MEMORANDUM

To: Design Review Board
From: Angela Ruggeri, Senior Planner
Date: August 17, 2015
File No.: DRV15-01250
Subject: **POTALA VILLAGE
DESIGN RESPONSE CONFERENCE**

Envelope Sun and Shading Study

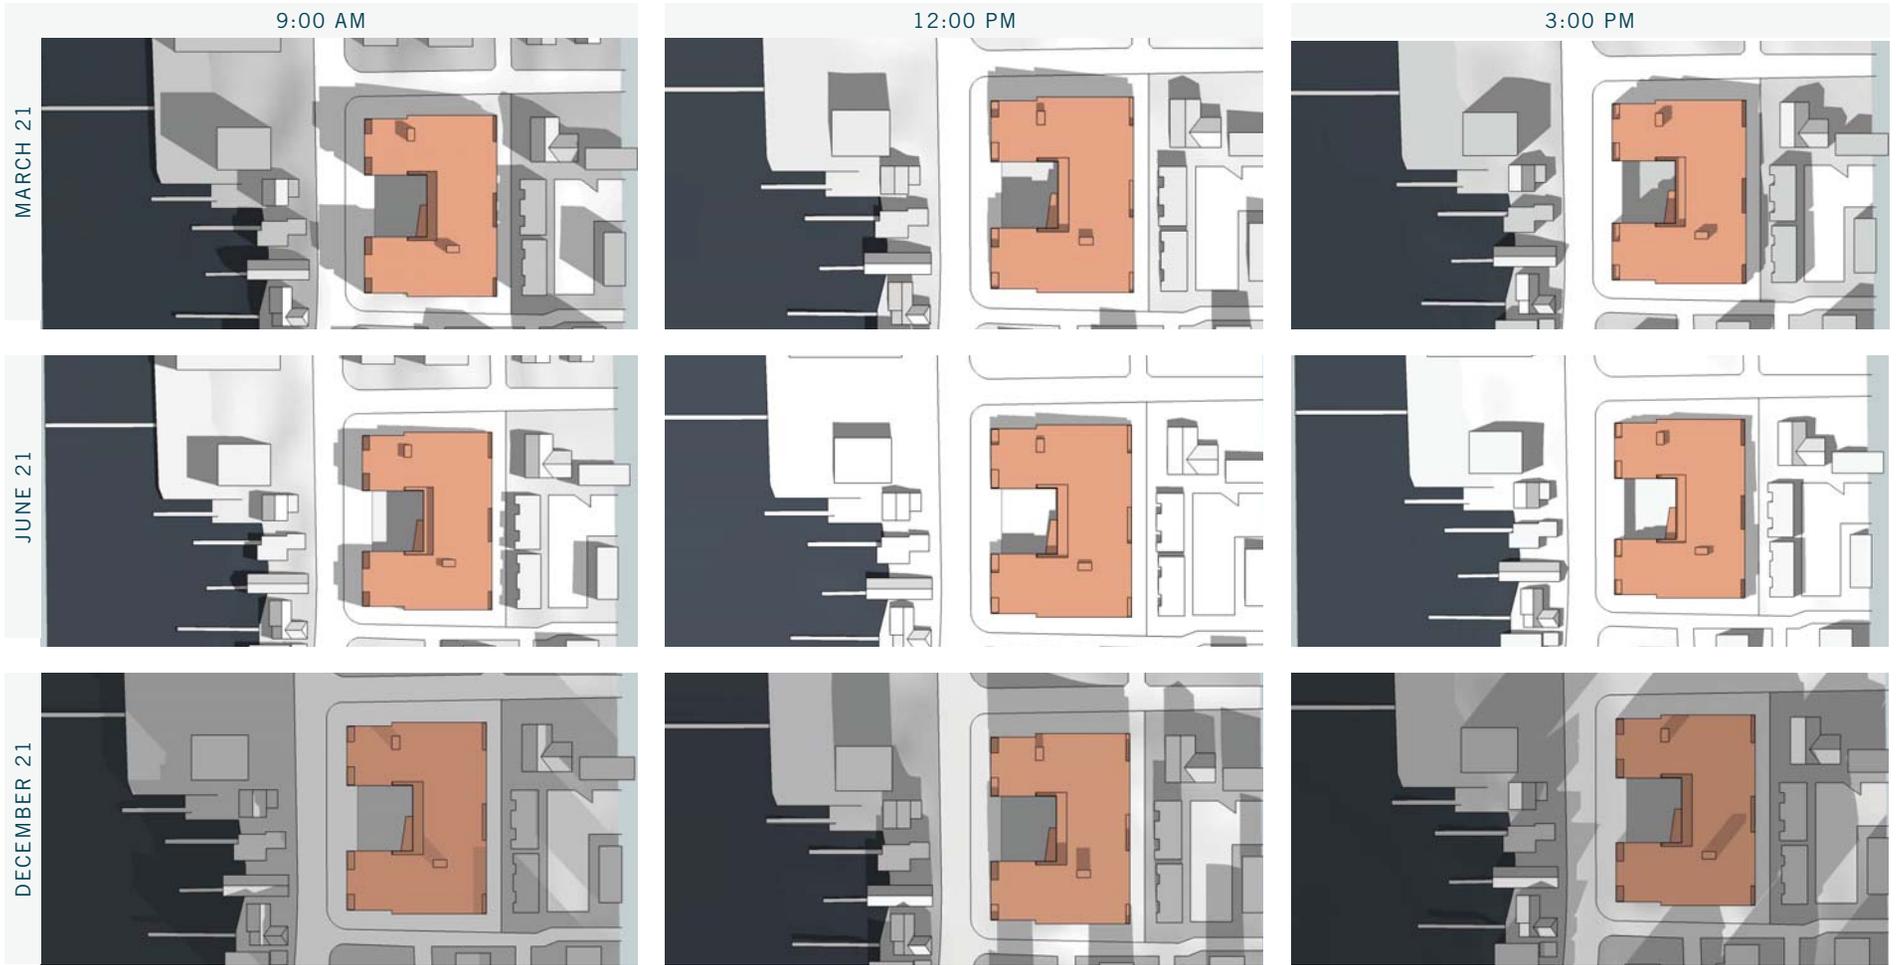
- *Does the proposed landscaping support central courtyard and U shaped building?*
- *Does the plan avoid having a shaded courtyard? The sun and shade diagrams on page 33 show that the courtyard works well in the summer months in particular.*
- *Has the west wall of the courtyard been given enough special attention since it is an important area?*
- *Are the east and south buffers adequate?*

Exterior Materials

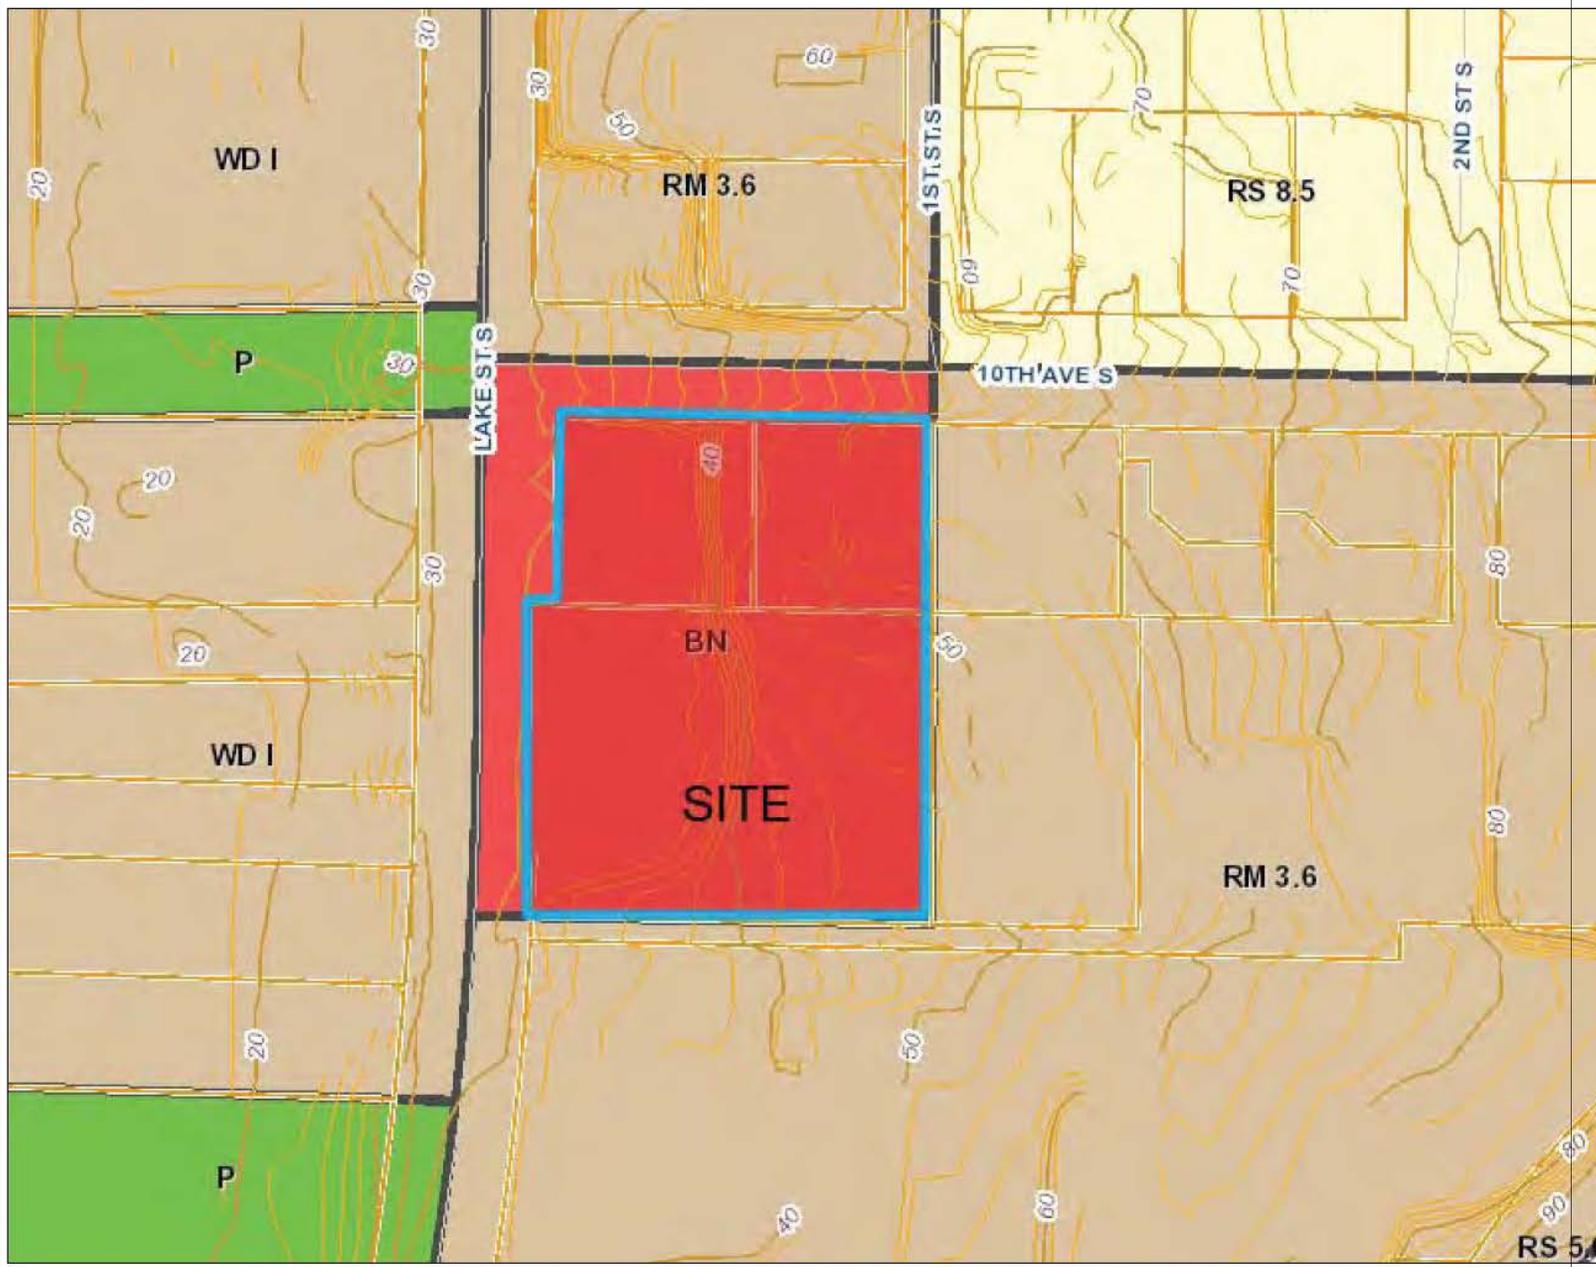
Attachment 1 contains color elevation and perspective drawings, but does not callout the proposed building materials. The DRB should provide feedback to the applicant regarding the materials and colors.
